MAG 4 (ปลายเรียว), (ปลายหนา)				
(C)	128	Flat Head Rivet No.7 ยาว	-	
(B)	4	Brake Lining Set ( B = 4 Pcs., C = 64 Pcs. ) Area 40,824 sq.mm.	-	
(A)	4	Brake Lining Set ( A = 4 Pcs., C = 64 Pcs. ) Area 41,904 sq.mm.	-	
Itemref	Quantity	Title/Name, designation, material, dimension etc		Article No./Reference
Designed by		Checked by	Approved by - date	File name:
			-12/02/2020	Unit : mm.
Title			ASIA COMPACT INDUSTRY CO.,LTD.	
Part Number			Drawing Number	Edition
-			DWL112532-01110	1
			Sheet	1

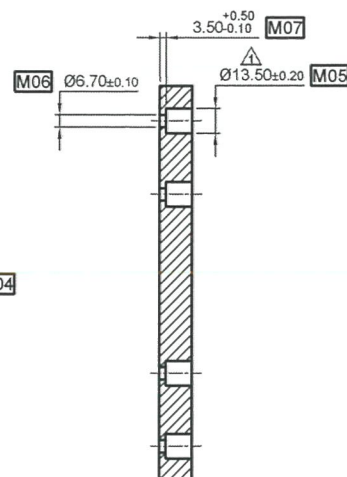
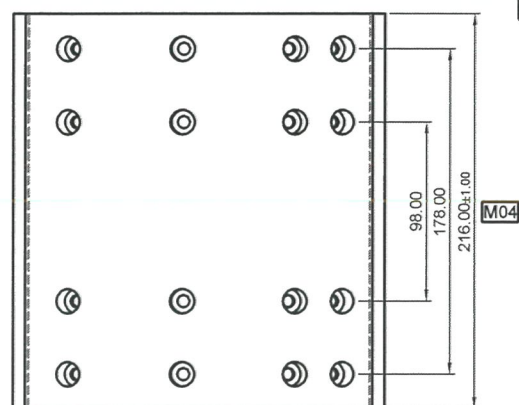
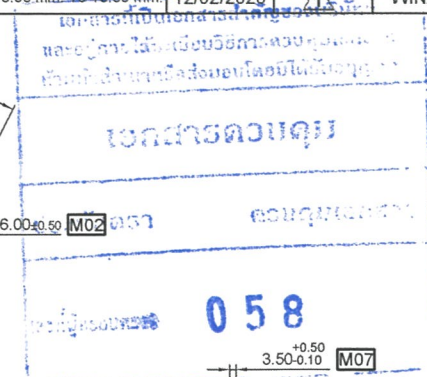
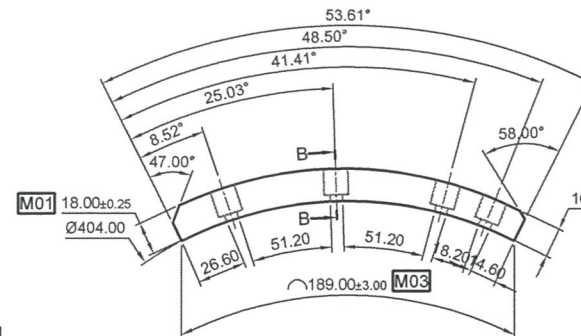
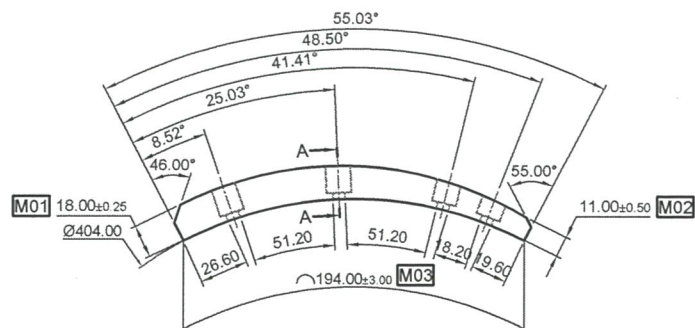
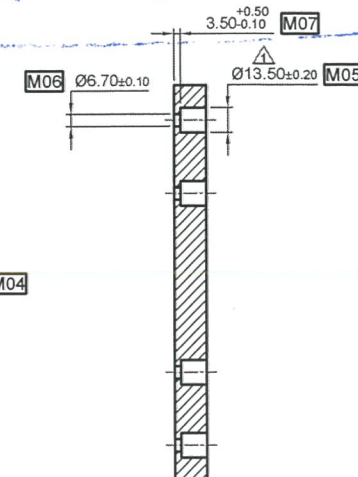
Rev No.	Ecn No.	Revision note	Date	Signature	Checked
01	E62/042	Change the boring hole from 13.00 mm. To 13.50 mm.	12/02/2020		WINAI
